FPIX1 Software Pass-Through Rev 1.3

The only difference between Rev 1.2 and Rev 1.3 is DATA_VALID is a single ended input. R53 must be removed. This version created to accomodate a faulty DATA_VALID driver on the pixel module.

Title:	SW Passthru to New FPIX1 Inner Board. JN1/JN2 signals.
Name:	Bradley Hall.
Date:	April 8, 2003
Sheet	1 of 4

Title:	SW Passthru to SAMTEC C and D.
Name:	Bradley Hall.
Date:	April 8, 2003
Sheet	2 of 4

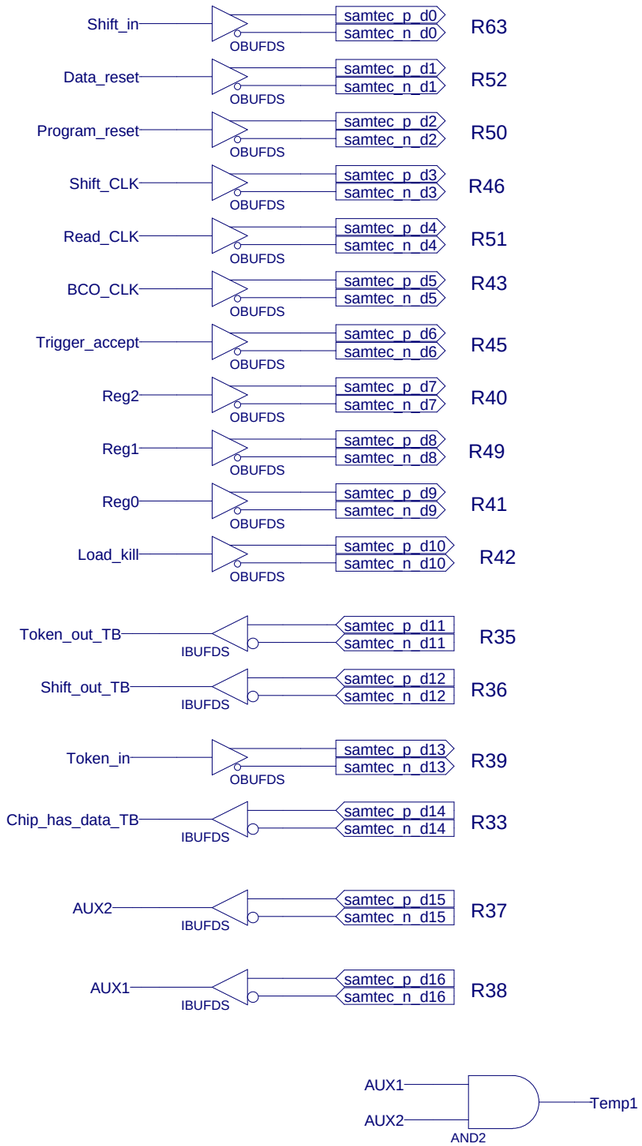
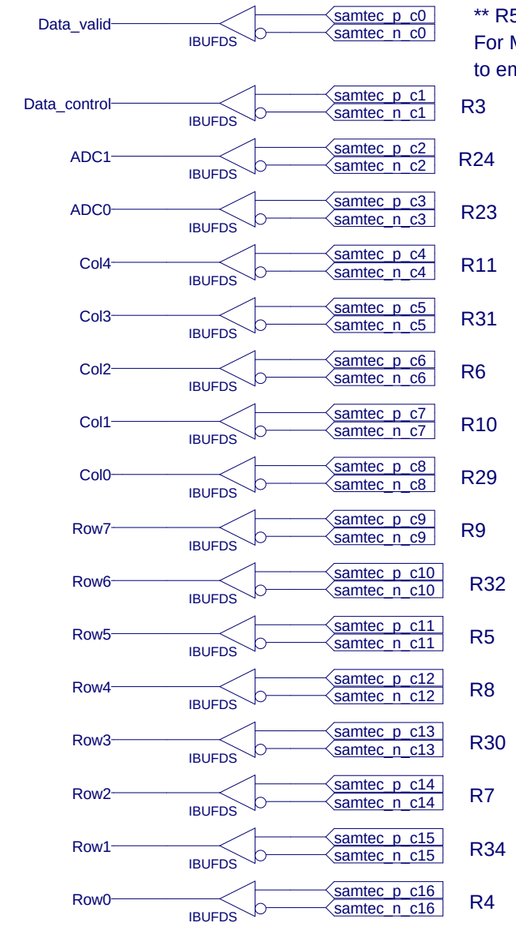
** R53 must be removed for Module**
For Module connect neg side of R53 to Bias Level
to emulate differential input. FPIX1 modules with
5 chips only has a DataValid swing of ~0 to ~1.3V.
